RCRA Comprehensive Groundwater Monitoring Evaluation (CME) Report

LANDFILL #5
Utah Test and Training Range
Department of the Air Force
UT0570090001

Division of Solid and Hazardous Waste
Department of Environmental Quality
State of Utah

FIGURE 5 Groundwater Flow-direction Map 1995

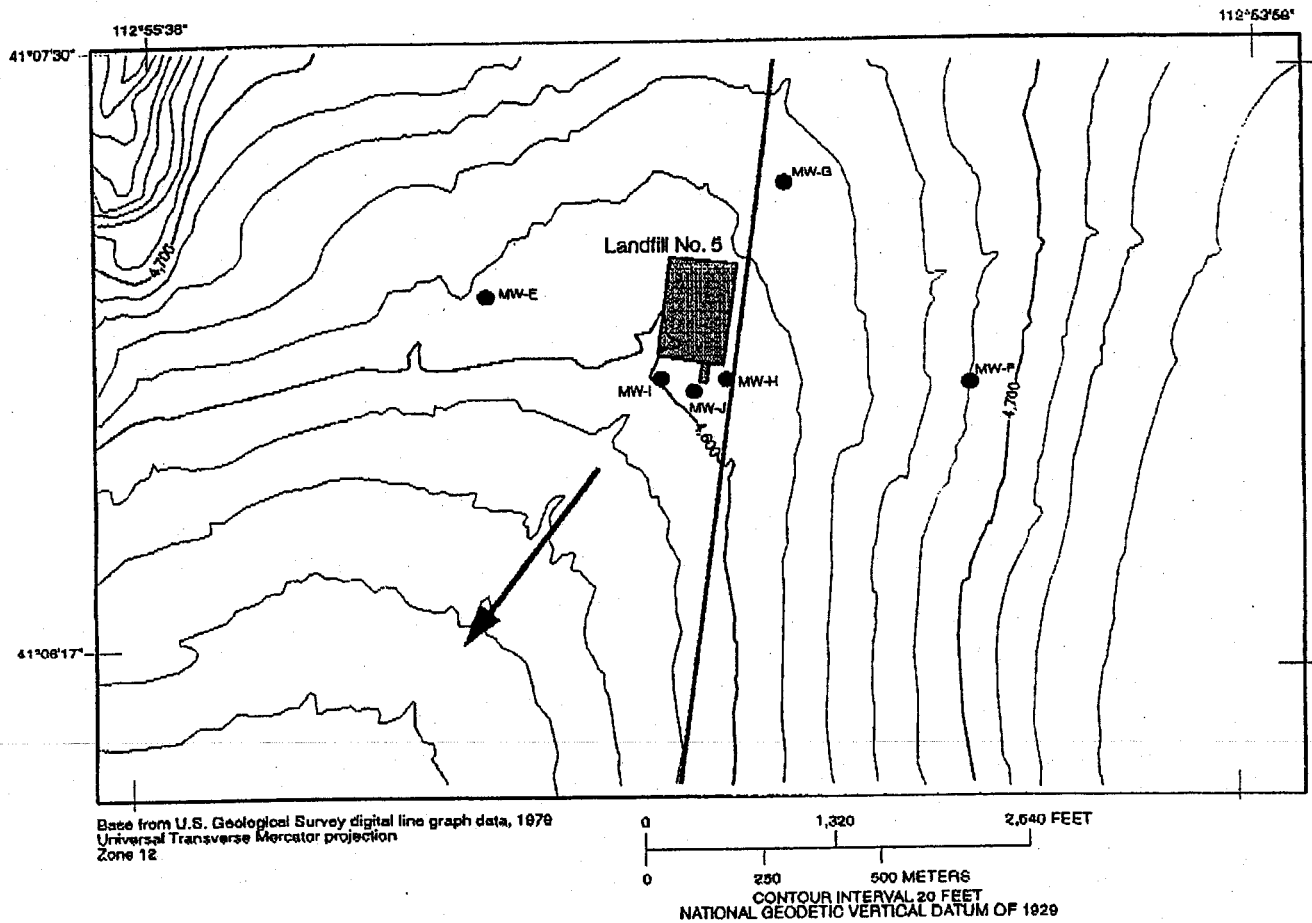
and 7). They show the groundwater flow direction going in three different directions in three successive years. This is particularly true for the 1995 data which shows north, south, and west groundwater flow directions within less than 1,000 feet of each other, all at the same time. In 1996 the flow direction was shown to be only to the south, and in 1997 the flow direction was shown to be only to the north.

There are several possible explanations for the confusing and conflicting groundwater flow directions. One is the groundwater elevations measured in the wells around Landfill #5 are incorrect. This could be caused by either bad down well measurement techniques, by incorrectly surveyed well tops, or due to wells that were not exactly plumb. Alternatively, Landfill #5 could sit at or near a groundwater high or divide. This setting would produce true groundwater flow away from a local groundwater high (either dome or ridge) in two or more directions. For this to be true the site must be a recharge zone. The physiographic setting of Landfill #5 is not that of a typical groundwater recharge zone.

FIGURE 8 Groundwater Contour Map 1999

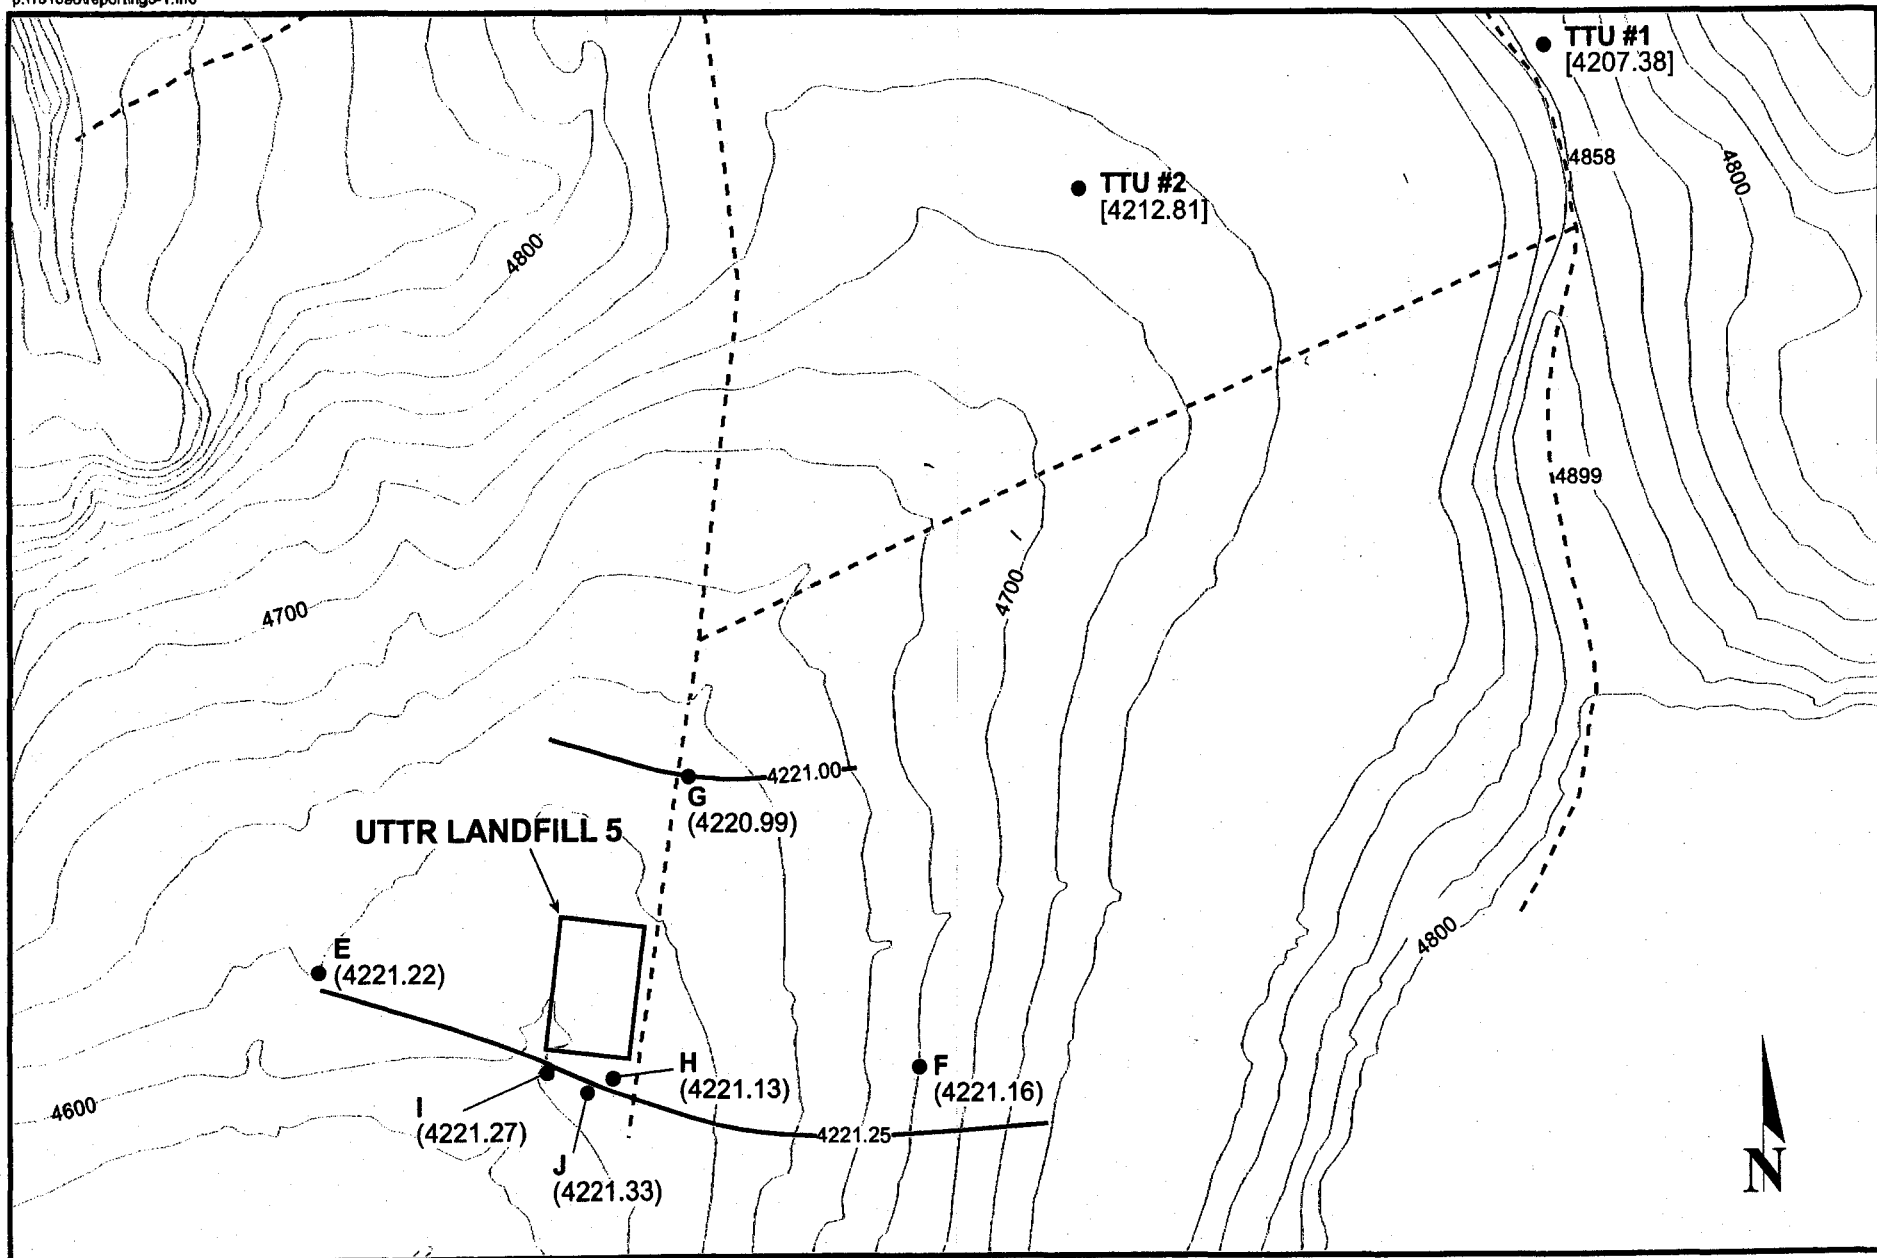
The inclination measurements were used to correct the static groundwater elevations, and then to generate a corrected piezometric surface contour map. Figure 8 shows the final corrected groundwater elevations and interpreted piezometric surface. The gradient slopes to the north, up valley, and then east through Sedal Pass. The wells at the TTU were not included in the inclination survey, so their groundwater elevations are not corrected. However, the expected elevation corrections for these wells (estimating from the average correction found for the Landfill #5 wells) is not sufficient to change the groundwater flow direction. It should be noted, that the final corrected data does show a very flat gradient of only 0.00018 feet/foot in the vicinity of Landfill #5.

Before this flow direction is considered for compliance purposes, additional semiannual monitoring events need to be conducted to verify the first round of truly accurate measurements.
